**CONSTRUCTION OF NEW FOUNDATION
AND RAISING EXISTING RESIDENCE FOR
CRISTINA & CHRISTOPHER LAUDANO RESIDENCE
145 MEADOW STREET
EAST HAVEN, CONNECTICUT 06512**

ADDENDUM NO. 2306-1

Date: December 15, 2014

Application No. 2306
LAA Project No. 1524-03

A-201

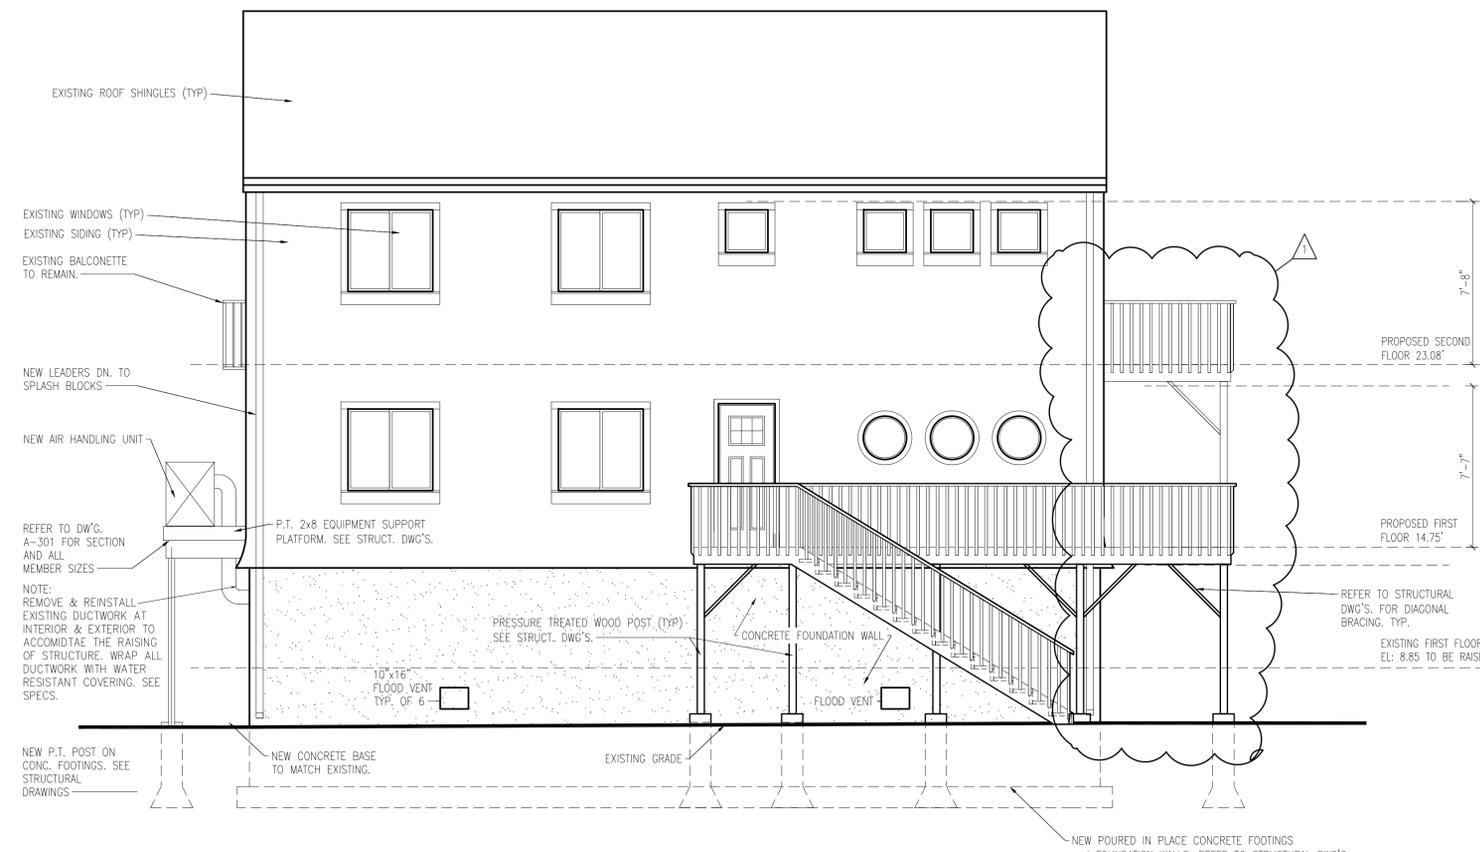
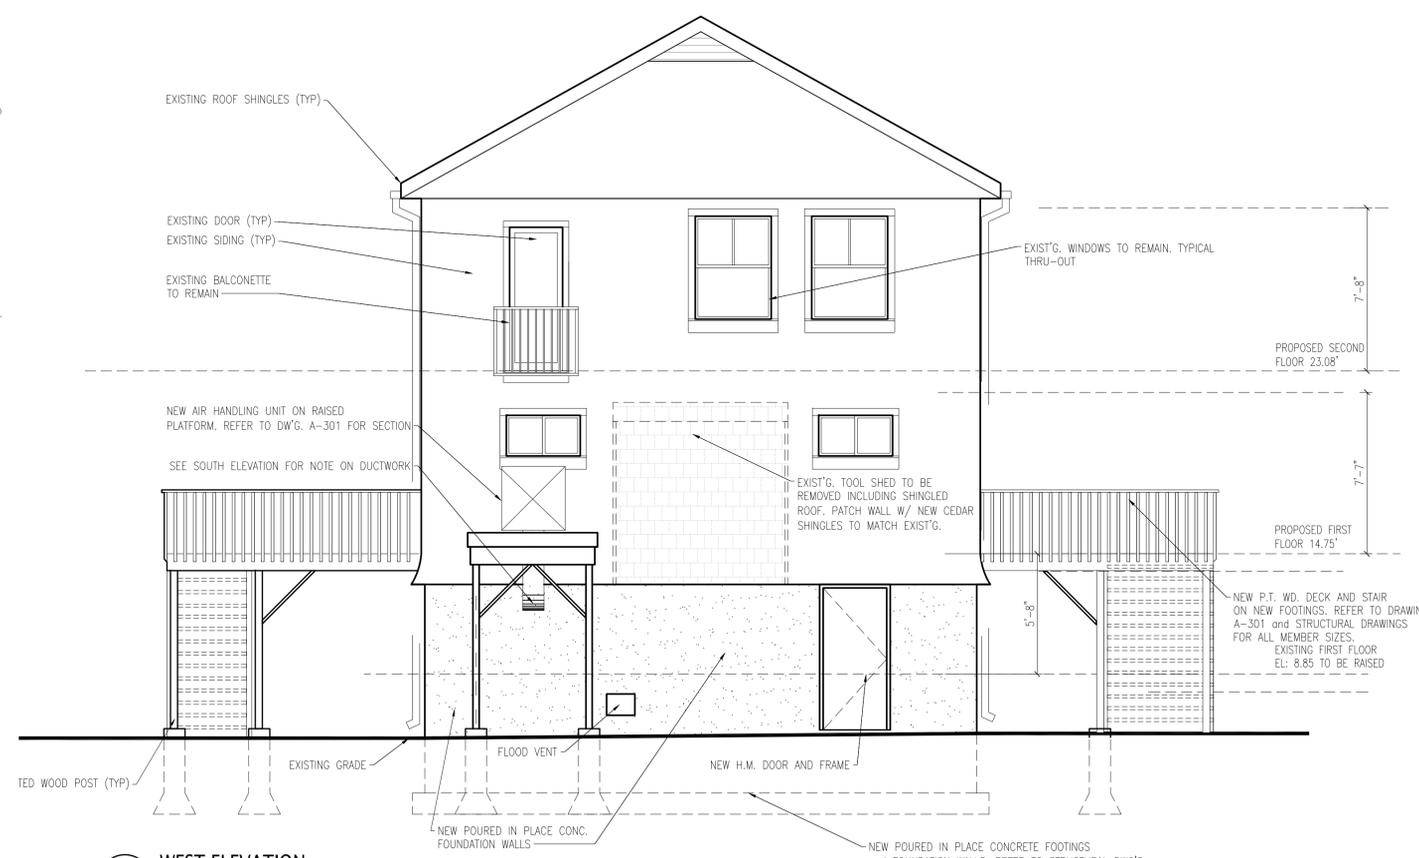
Revise exterior decks and stairs and related structural details as shown on the attached revised drawings.
